CIVIL CONSTRUCTION PLANS LOT 2 ELM GROVE VILLA COLORADO SPRINGS, CO 80911 - EL PASO COUNTY SMITH PLUMBING & HEATING

PPR2143

EPC STORMWATER REVIEW COMMENTS IN ORANGE BOXES WITH BLACK TEXT

COVER SHEET

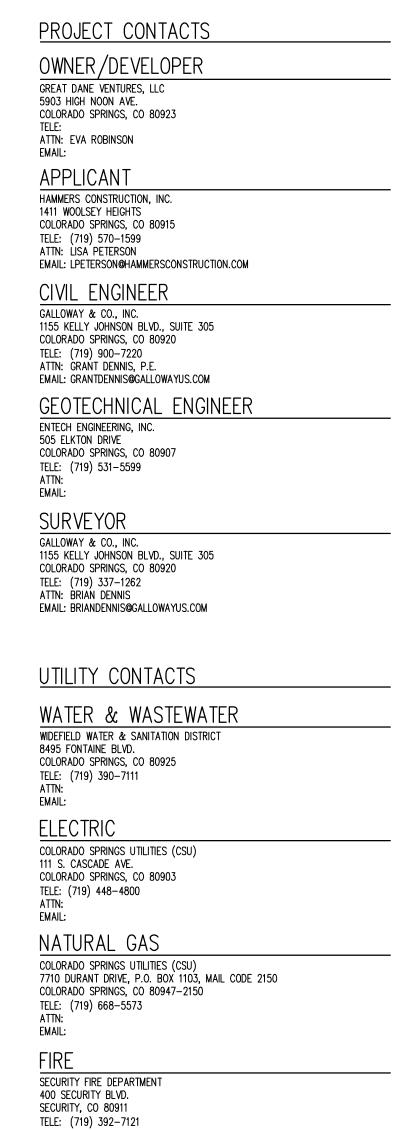
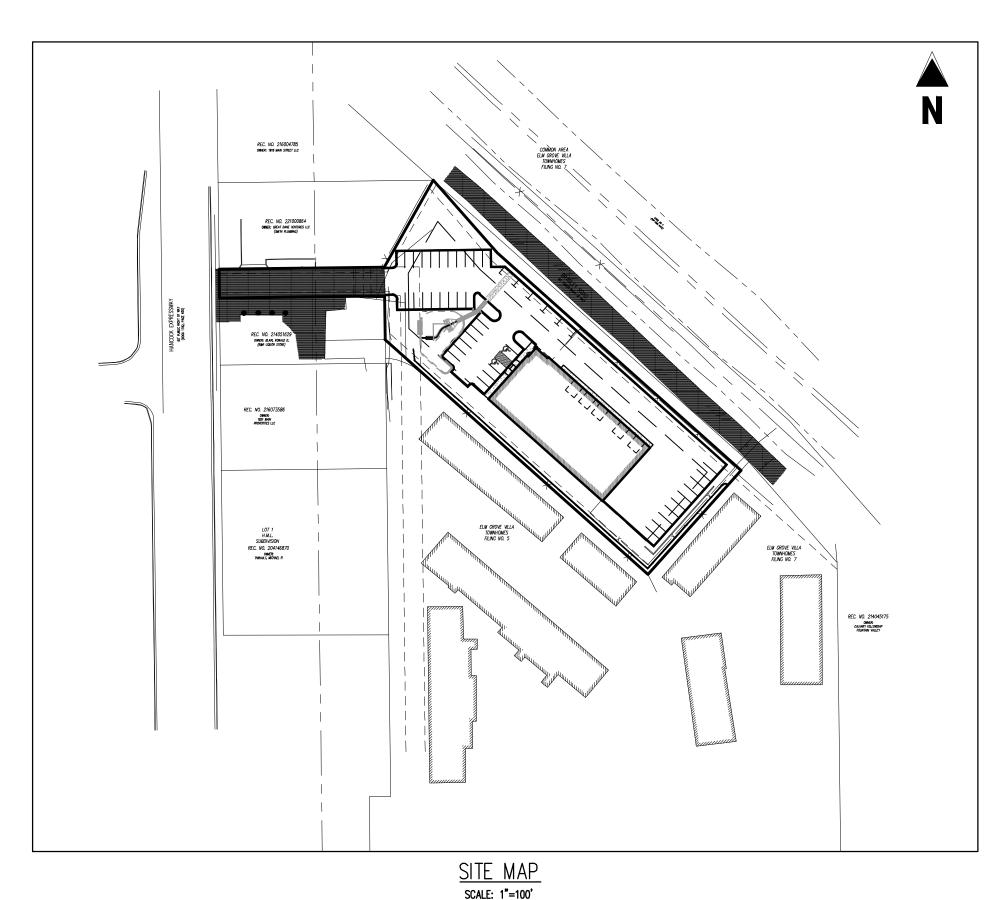
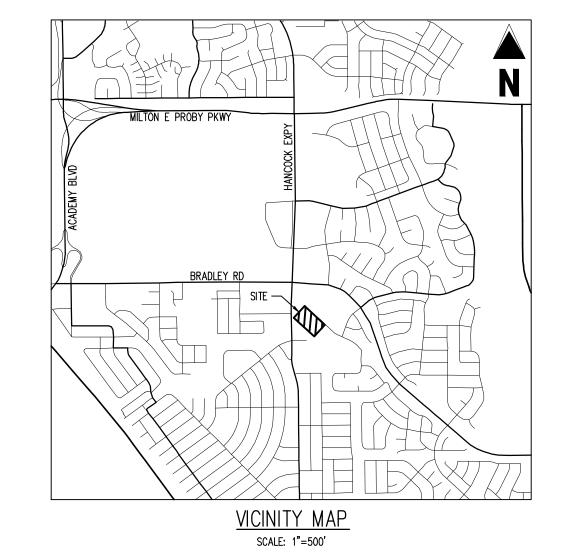
Add PCD Filing No.:
